**PLANNING COMMISSION
Meeting Agenda
Monday – July 13, 2009
7:00 PM - Regular Meeting
City Council Chambers – 155 NW 2nd Avenue**

STAFF REPORT

NCS 09-01

APPLICANT'S PLANS

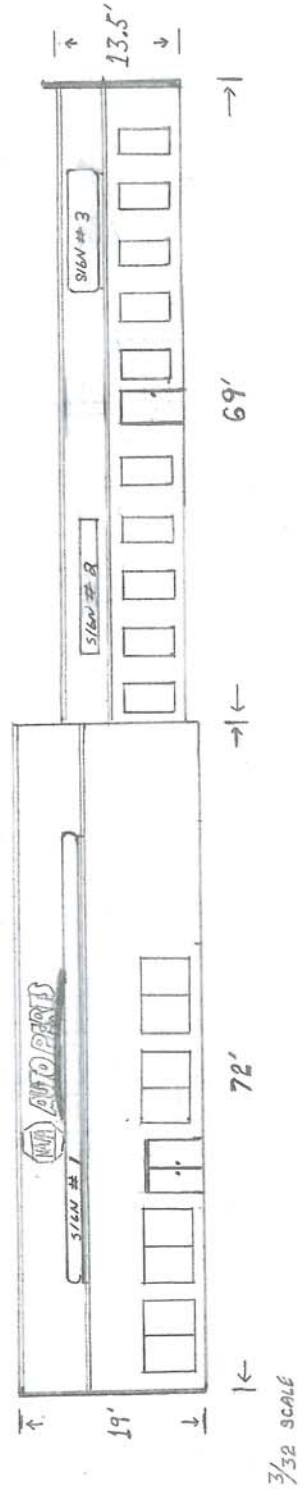
② Two additional wall signs on west end of building frontage – these are the 2 non-conforming signs that the applicant wishes to replace. The sign on the left is approximately 24.5 square feet in size, and the sign on the right is approximately 31.25 square feet in size.

③ Different angle showing same two wall signs that the applicant wants to replace.

IT IS ORDERED BY THE PLANNING COMMISSION of the City of Canby that **NCS 09-01** is approved, and the applicant is hereby allowed to remove Sign #2 and Sign #3 from the west end of the primary building frontage, and replace those signs with one new 33'x1.5' sign, as detailed in the Applicant's Plans, Exhibit D to the staff report.

1 FLOOR PLAN
2 2033 SF 1/4" = 1'-0"

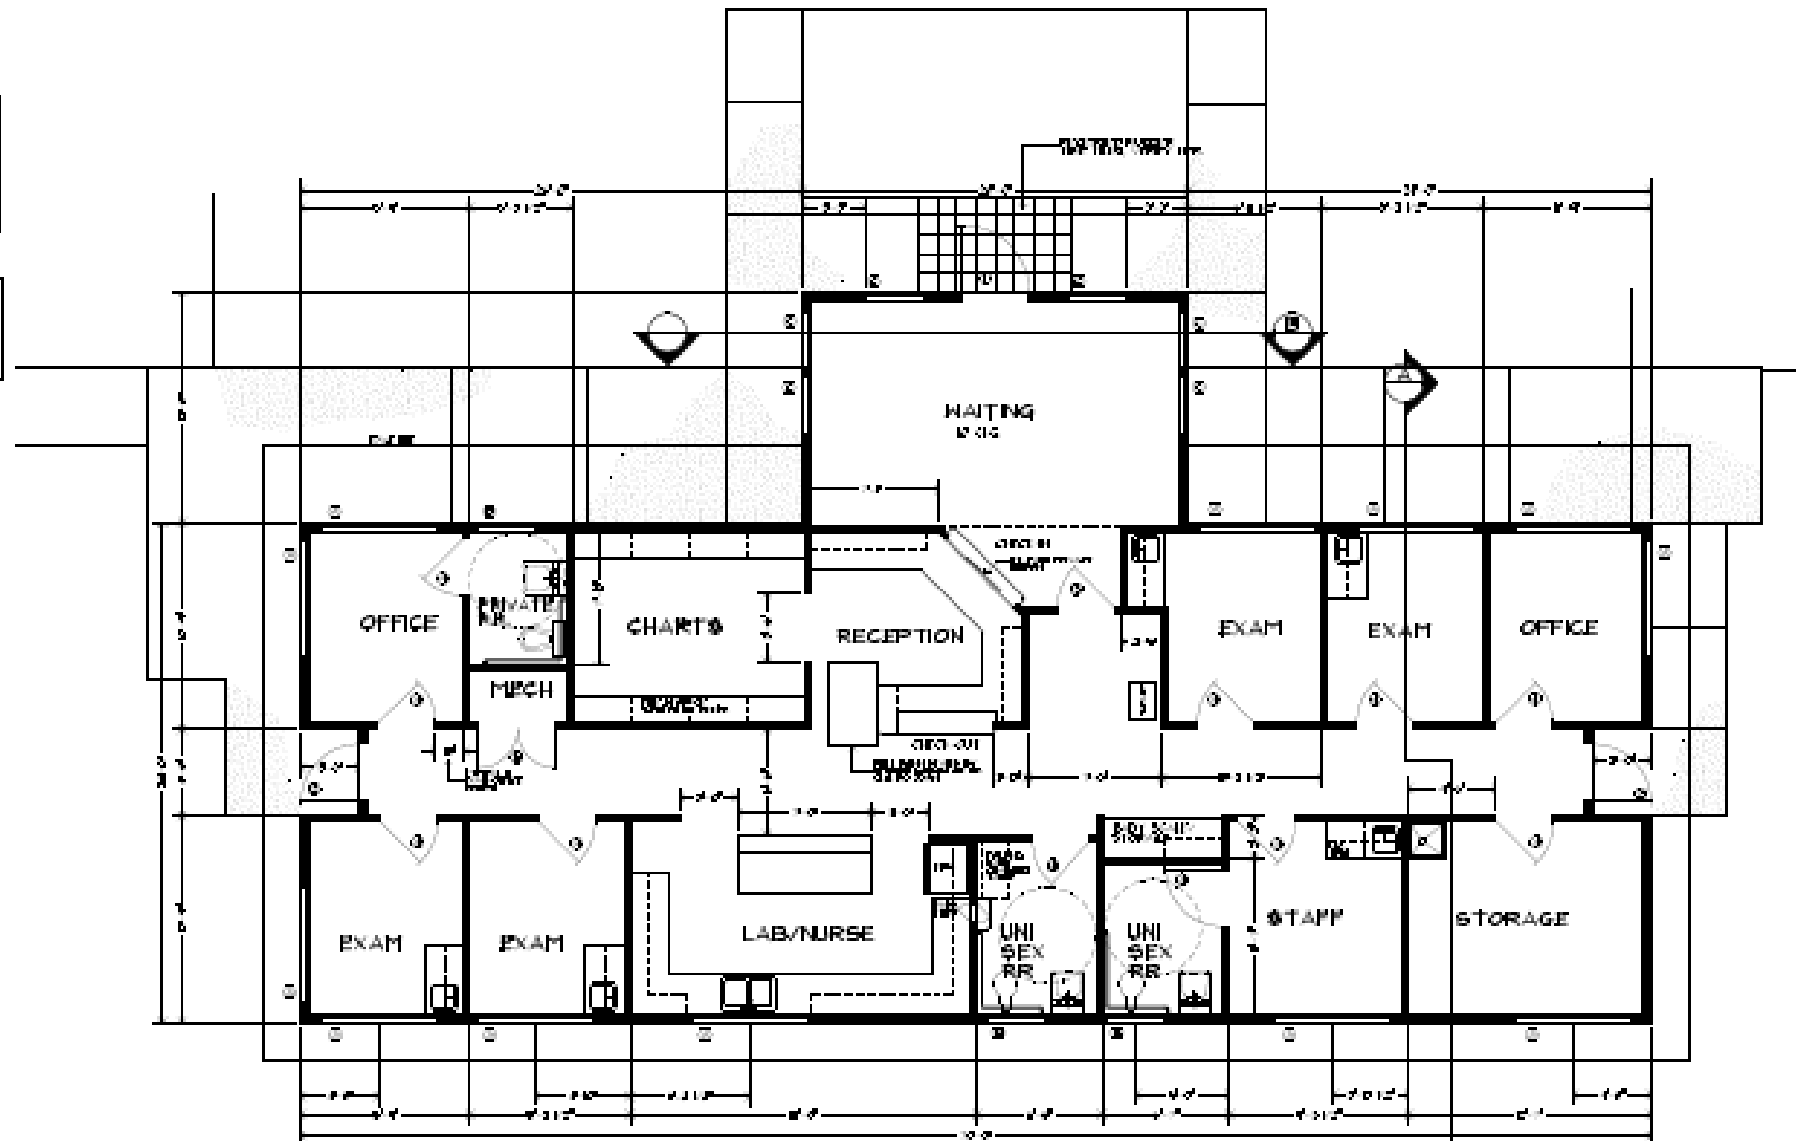
- The color of the fiber-cement lap siding on the exterior of the building (*see sheet 1/3 of Applicant's Plans – Exhibit D to staff report*), shall be a subdued beige or brown that is similar to the exterior siding color on the existing medical office building located on the opposite side of the shared driveway. Exterior of building shall meet this condition prior to the City issuing a final occupancy permit. (*condition #8*)

8. The color of the fiber-cement lap siding on the exterior of the building (*see sheet 1/3 of Applicant's Plans – Exhibit D to staff report*), shall be a subdued beige or brown that is similar to the exterior siding color on the existing medical office building located on the opposite side of the shared driveway. Exterior of building shall meet this condition prior to the City issuing a final occupancy permit.

SHEET NUMBER
04

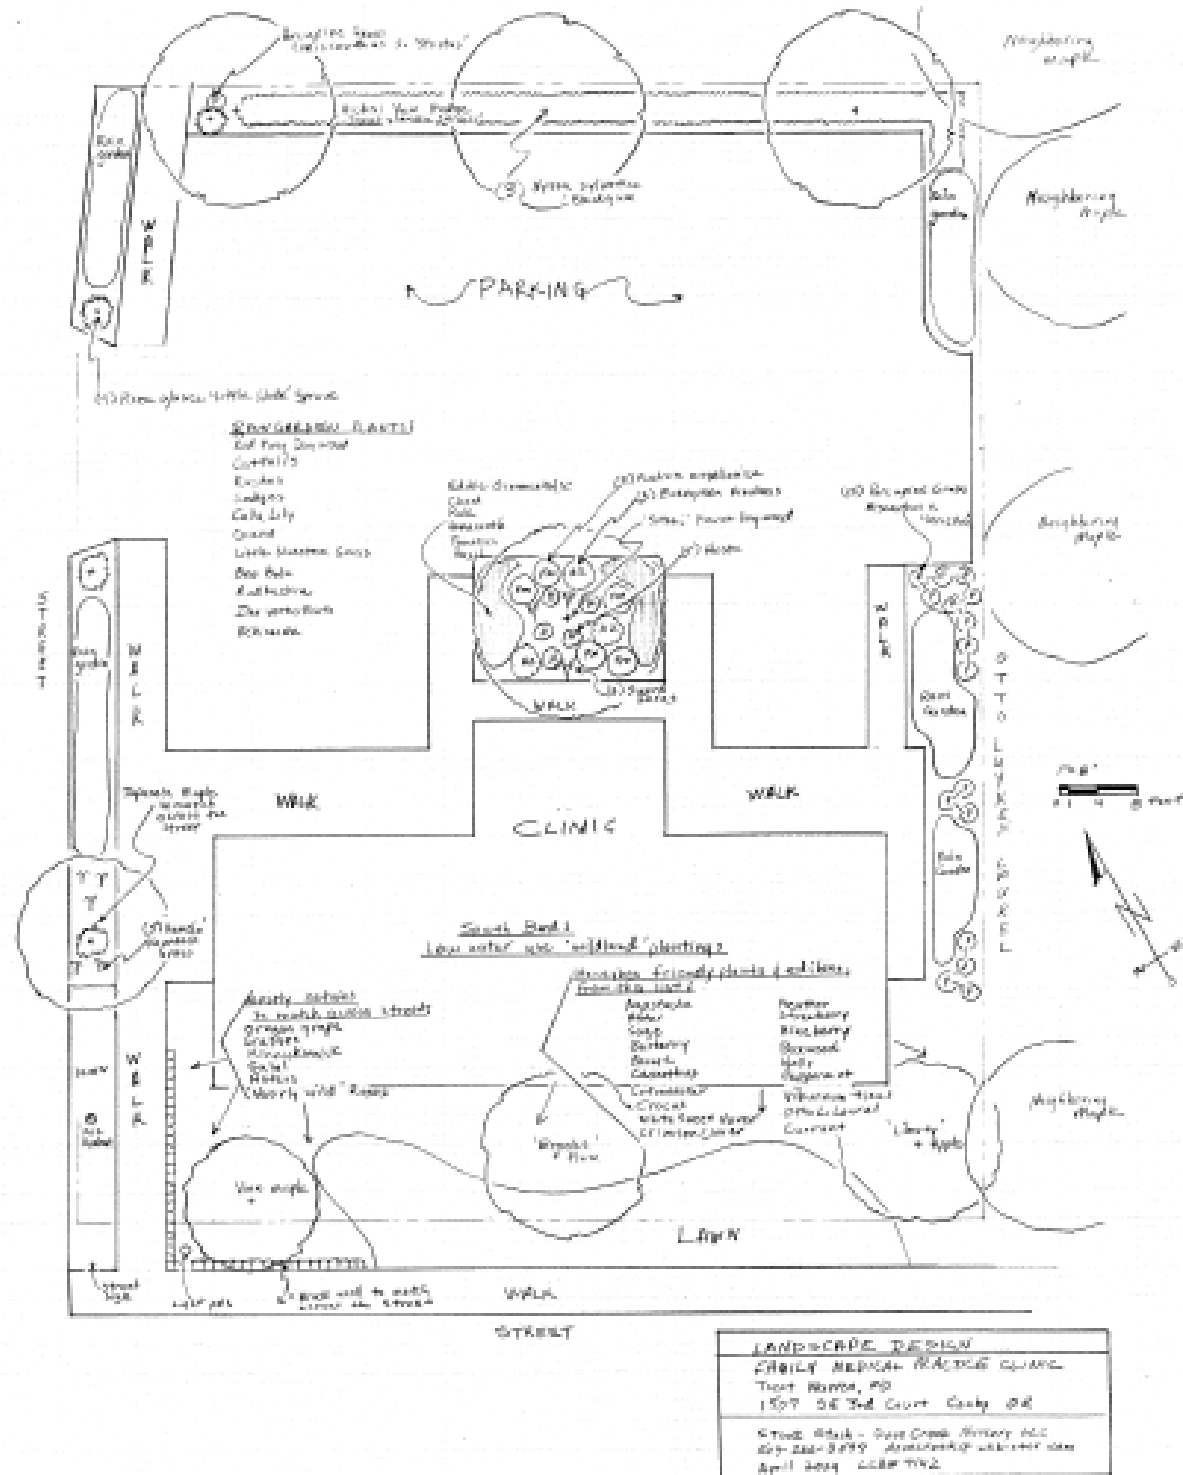
CMC 16.49.065 sets forth standards for on-site bicycle and pedestrian facilities and connectivity. The applicant’s site plan as proposed (see sheet C4 of Exhibit D) does not meet all of the code requirements. Therefore, Site and Design Review approval shall be conditioned upon the applicant meeting all of the requirements, including revising the site plan in order to provide walkway connectivity to the two abutting commercial lots, and in order to insure all pedestrian walkways are a minimum of 5 feet wide.

- Driveway approach must meet ADA guidelines.
 - *Planning Staff comments: The applicant's plans include no information as to whether the proposed secondary driveway meets ADA guidelines or not. Therefore, Site and Design Review approval shall be conditioned upon the driveway being constructed to meet this requirement of the City Engineer.*

- At the time of building permit application, the developer shall submit a revised site plan, that is in substantial conformance with the site plan submitted with the Site and Design Review application (*Exhibit D of staff report*), but that also revises the width of all on-site pedestrian walkways to be a minimum 5 feet wide, and that provides walkway connectivity to the two abutting commercial lots. All required improvements shall be installed prior to issuance of a final occupancy permit. (*condition #6*)

- The proposed secondary driveway, which provides access to the site from the primary shared driveway (S.E. 3rd Court), shall be constructed to meet ADA guidelines. Prior to issuance of a final occupancy permit, the applicant shall provide the Planning & Building Department with written documentation from the City Engineer that this condition has been met to the satisfaction of the City Engineer. (*condition #9*)
